NOTICE OF DECISION
MYRTLEWOOD SUBDIVISION TENTATIVE PLAN – SUB221-0002

November 26, 2021

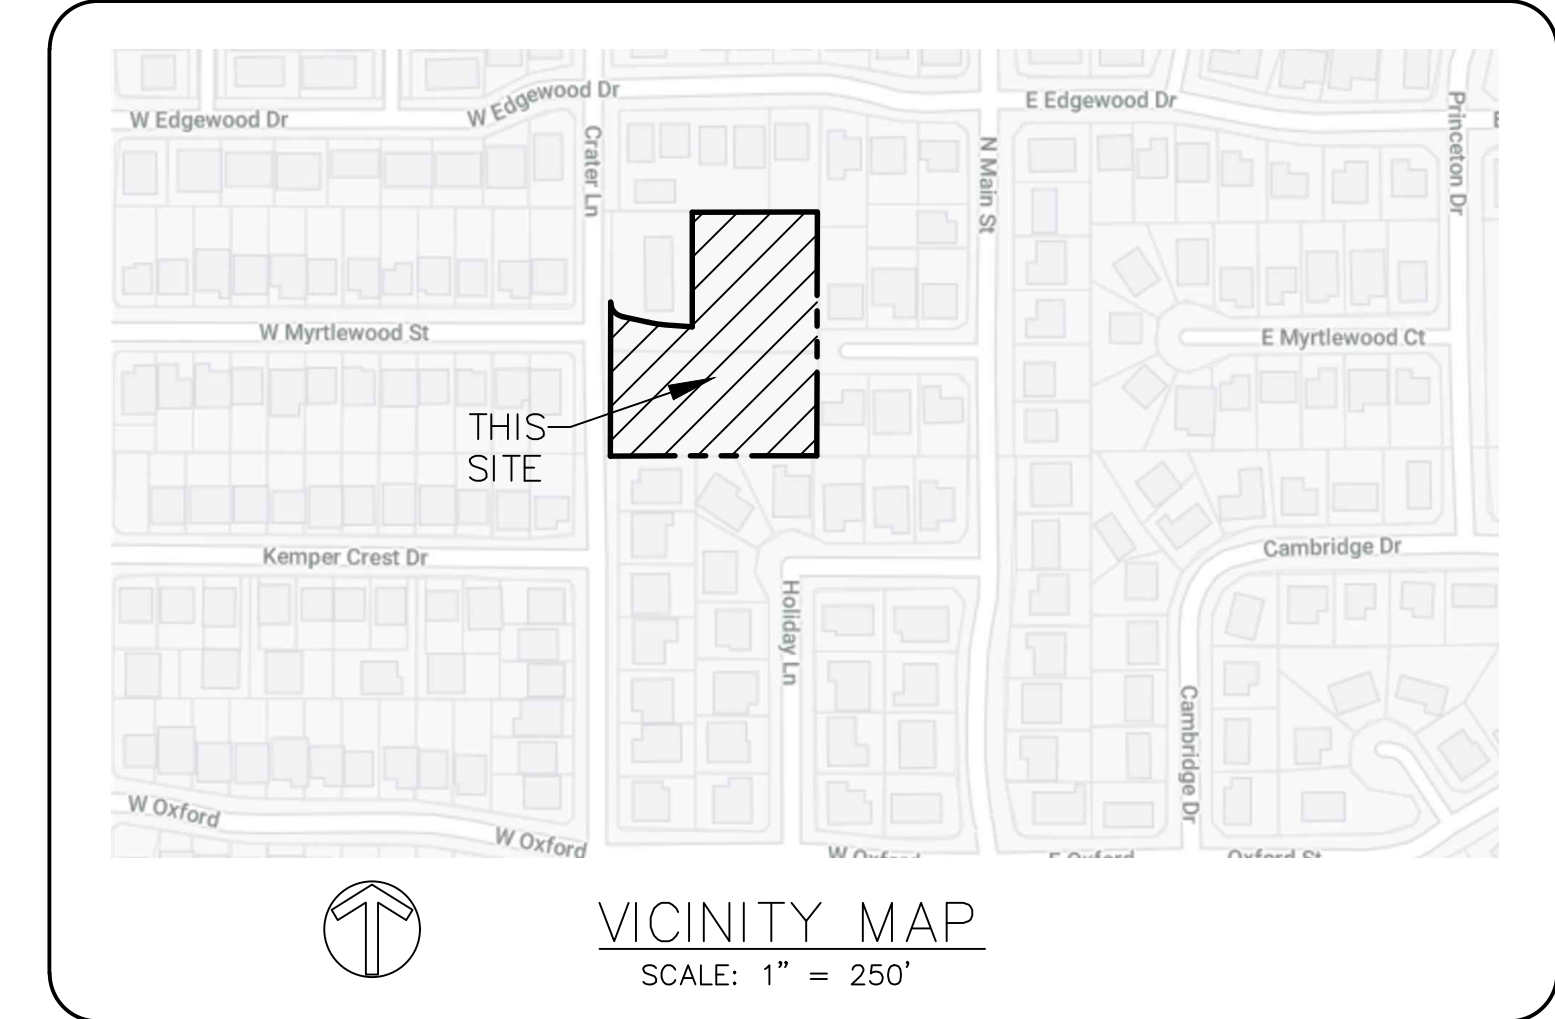
RESPONSE: All proposed improvements have been designed to meet the development standards of the Newberg Public Works Design and Construction Standards. Upon gaining land use approval for the proposed subdivision, the Applicant will be submitting detailed civil plans to the City's Public Works department for their review and approval to assure all public improvements are designed, constructed, and maintained in compliance with the City's public works design and construction standards.
